Maelor Foods, Pickhill Lane, Cross Lanes, Wrexham

Variation of Condition 07 of Planning Permission APP/H6955/A/18/3216187 to Permit the Processing of 2 million Birds per Week

Introduction

From:	Chief Officer, Environment & Technical	To:	Chief Officer Planning & Regulatory
Our Ref:	ET/DC/MZ/P/2022/0820	Your Ref:	P/2022/0820 Res(1)
Date:	02/07/2024

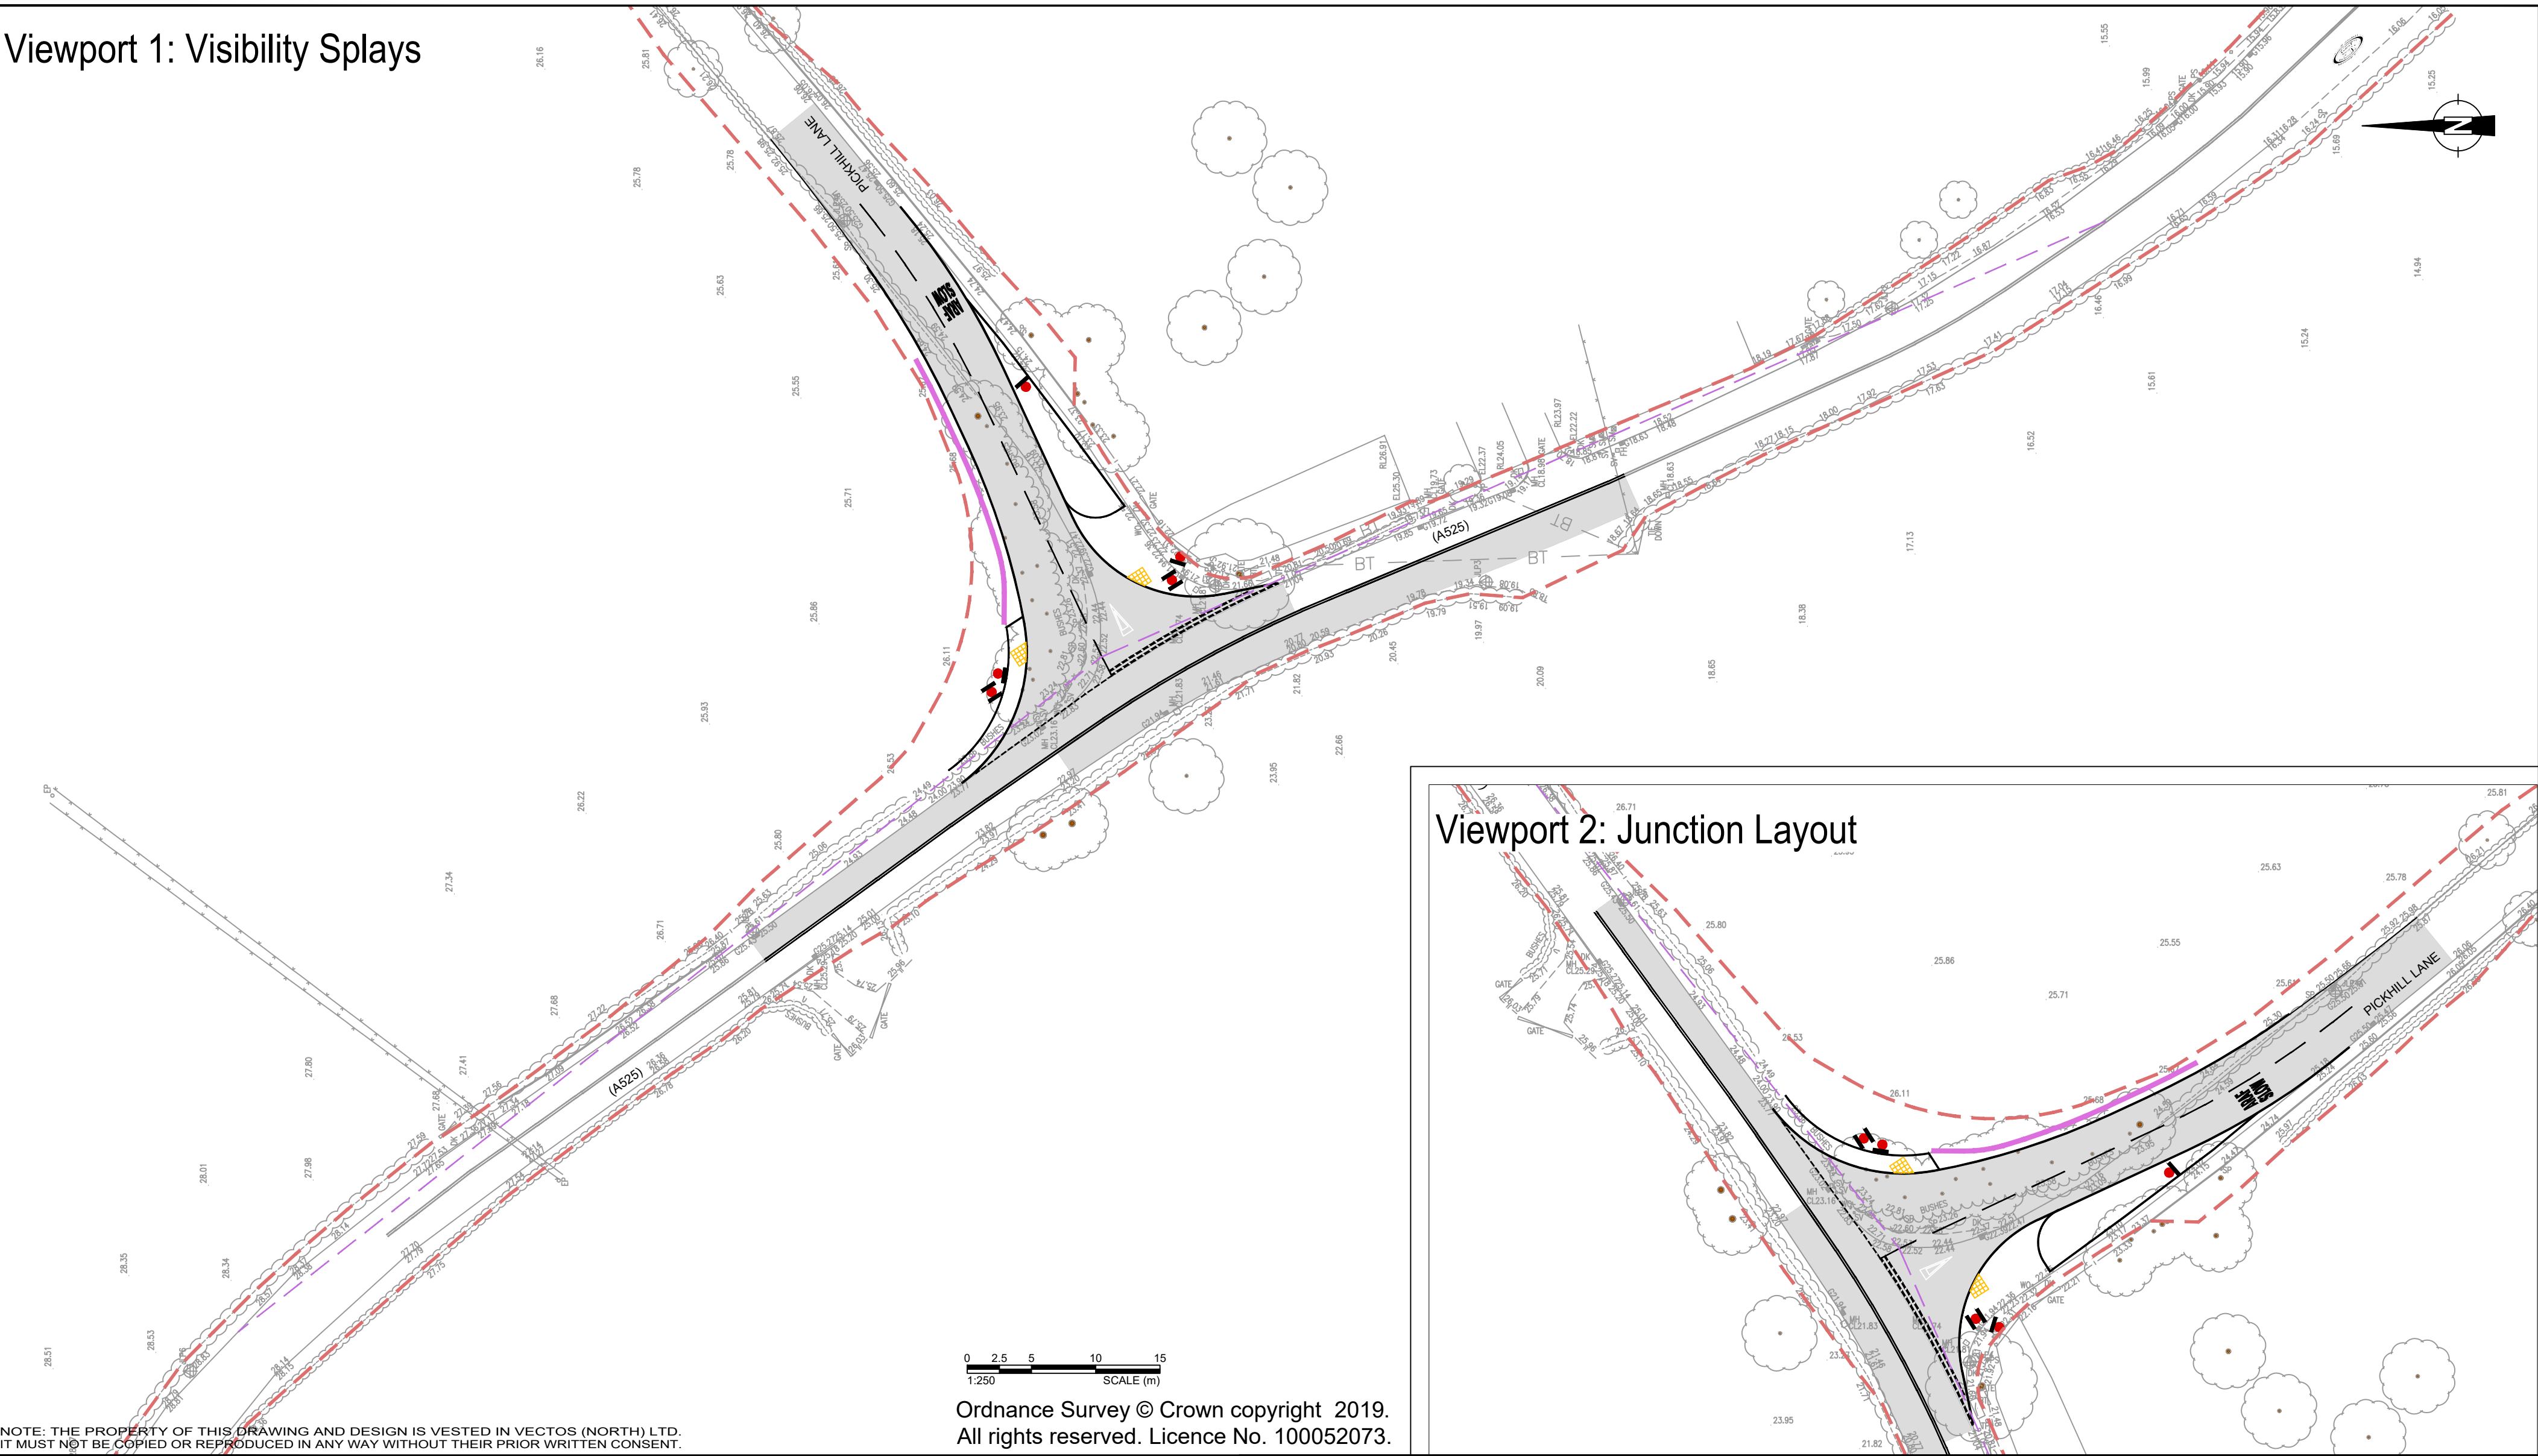
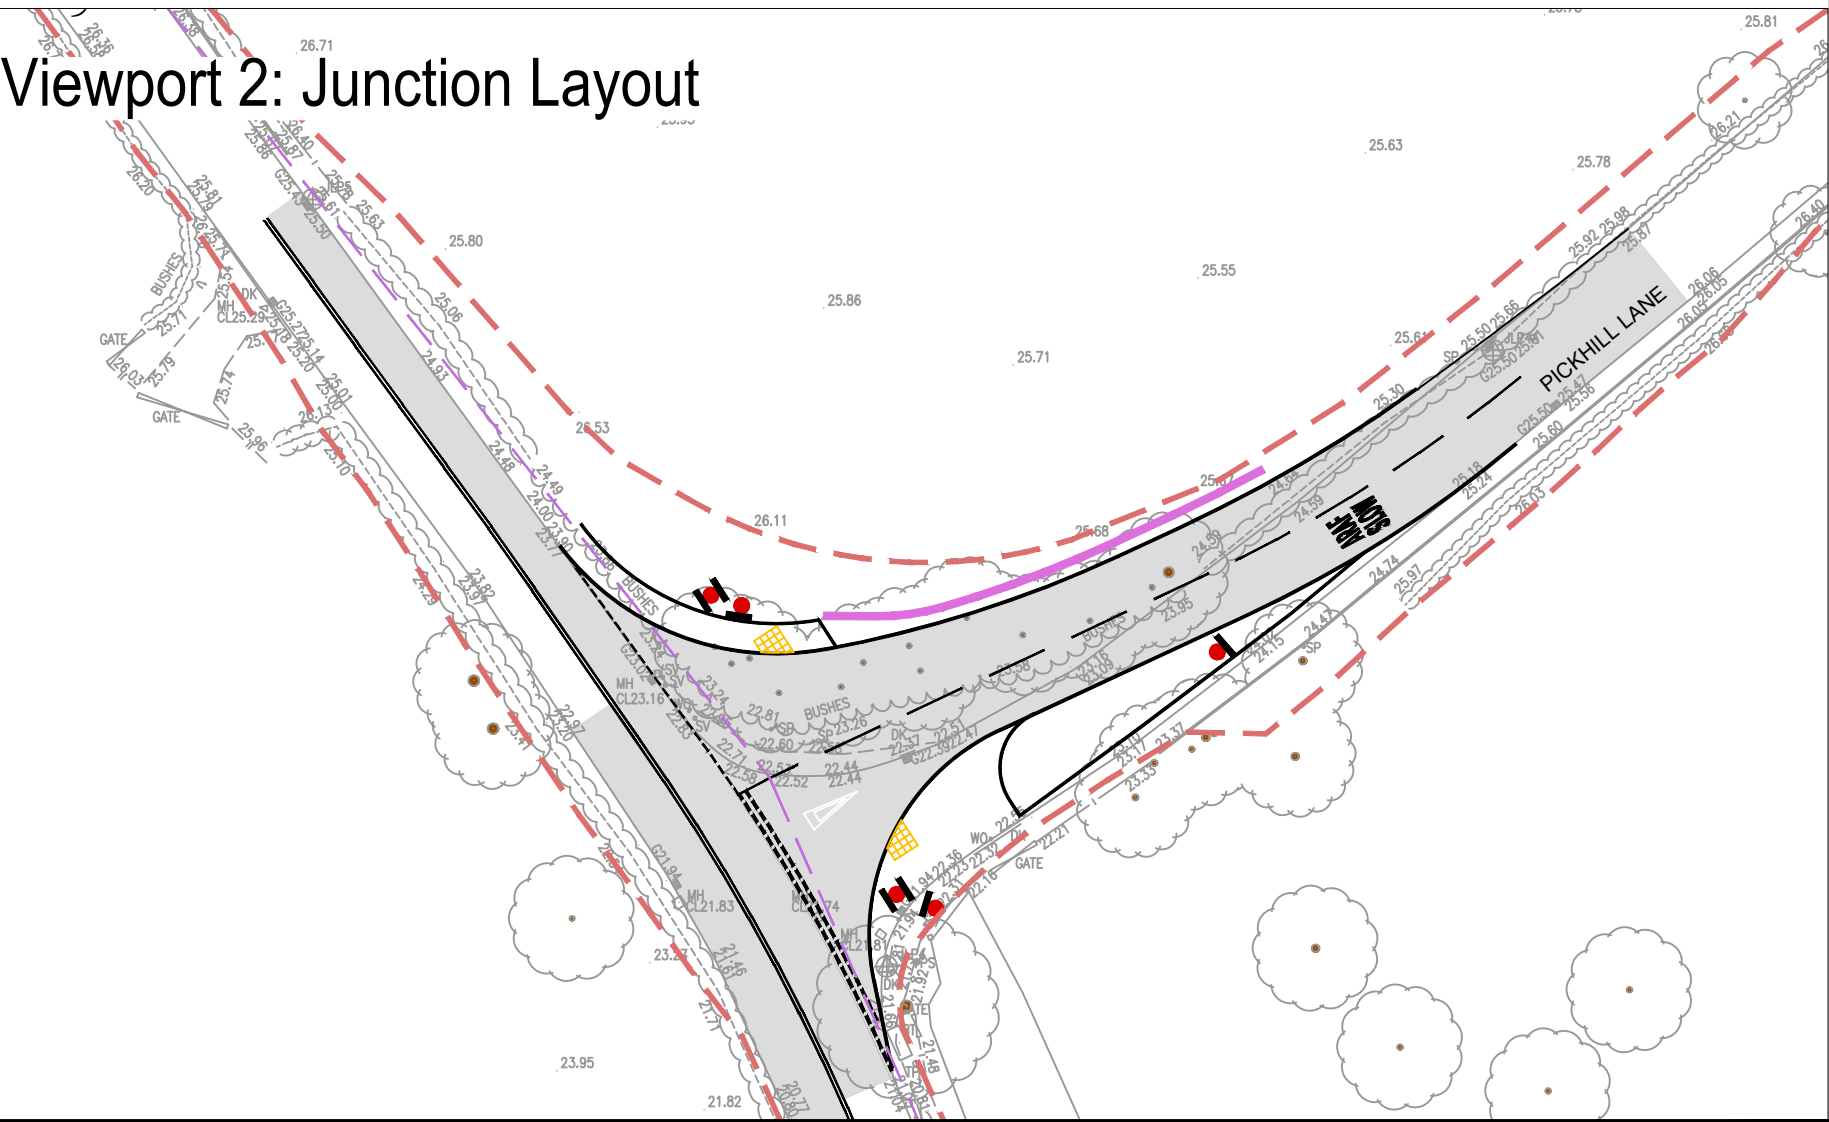
Furthermore an updated drawing with the visibility splays at the junction should be submitted.

Both horizontal and vertical visibility sightlines at the Pickhill Lane / A525 junction are presented on **Drawing VD190095/SK004** attached to the rear of this report. As is shown, suitable visibility can be achieved both in the vertical and horizontal plane and is consistent with existing visibility provided at the junction. As demonstrated by the vertical splay assessment, considering the existing road level / profile to the north, drivers have a clear and unobstructed 120m sightline from an eye height of 1.05m to an object height of 0.6m above the carriageway, ensuring no safety concerns. This height complies with the Manual for Streets (MfS) guidance.
